AGENDA
CITY OF KENTWOOD PLANNING COMMISSION
TUESDAY, JANUARY 28, 2025
KENTWOOD COMMISSION CHAMBERS
4900 BRETON AVENUE, SE
7:00 P.M.

PROPOSED MINUTES OF THE REGULAR MEETING
OF THE KENTWOOD PLANNING COMMISSION
JANUARY 14, 2025, 7:00 P.M.
COMMISSION CHAMBERS

STAFF REPORT: January 21, 2025
PREPARED FOR: Kentwood Planning Commission
PREPARED BY: Lisa Golder
CASE NO.: 4-25 Meijer Gas Station SLU and Final Site Plan Review in a PUD

APPLICANT'S Sketch PLAN For THE INTERIOR LAYOUT OF 3110 Broadmoor Building

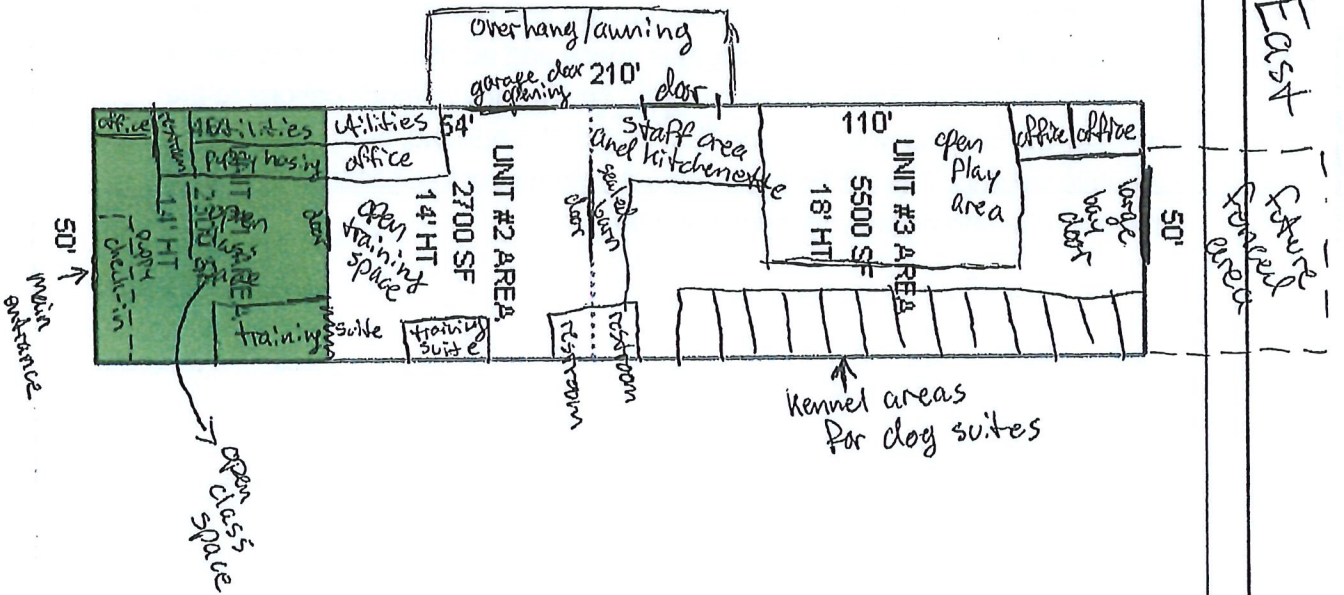
1. Applicant's Written Statement received on 12-9-2024.
2. Applicant's Sketch Plan for interior of 3110 building.
3. Outdoor exercise areas shall be enclosed by a sight-obscuring fence designed and constructed to provide secure containment of dogs in care.

1. The applicant's statement details the intended number of dogs that are planned to be in the three sections of the south building consistent with this minimum square footage requirement. The applicant also indicates that the existing north building accommodates 90-100 dogs considering

ELEVATION - SOUTH ALLOWED SIGNAGE: 91.5 SF
PROPOSED SIGNAGE: 30 SF

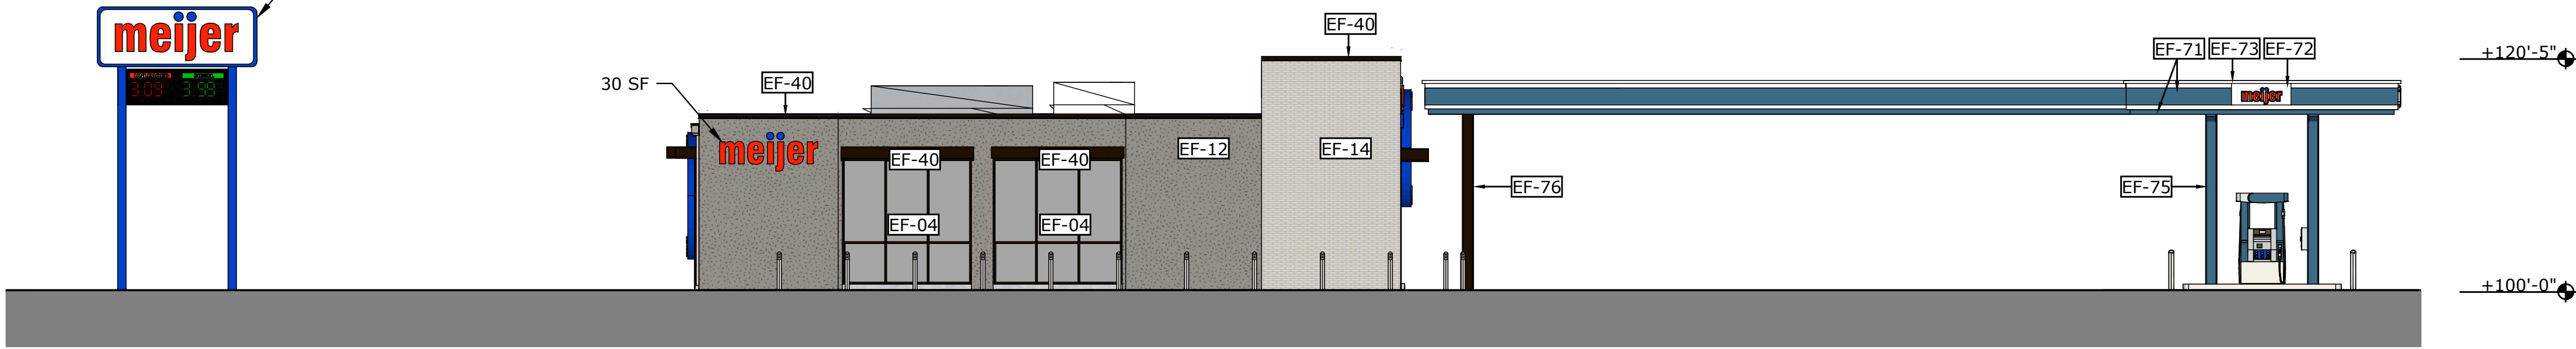
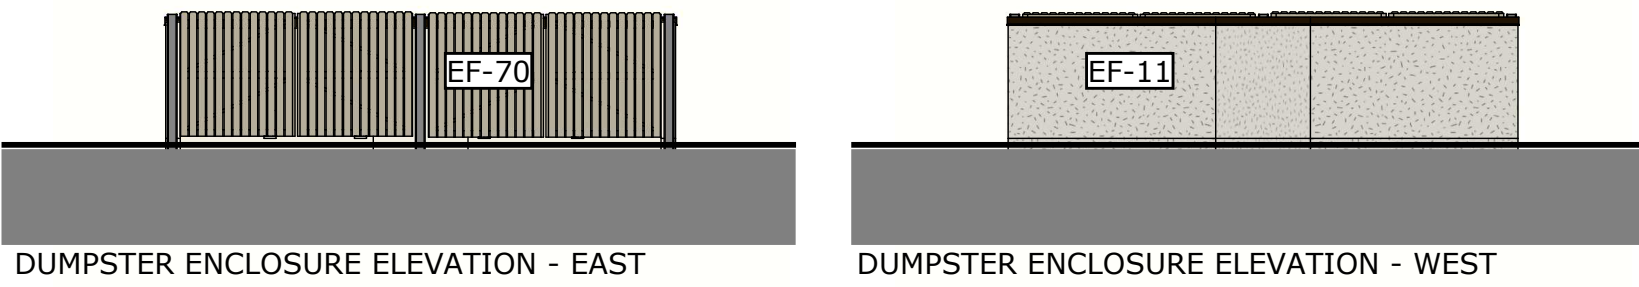
11. The zoning ordinance allows wall signage for walls facing a public street. The applicant has shown wall signage on all sides of the building. From a staff perspective, the gas station has street frontage on the south, east and arguably the west side of the building; no wall signage would be permitted on the north side.
12. The landscaping proposed along east side of the building could incorporate taller plantings that could provide additional interest to this side of the building.
13. The applicant shall indicate the amount of open space on the site.
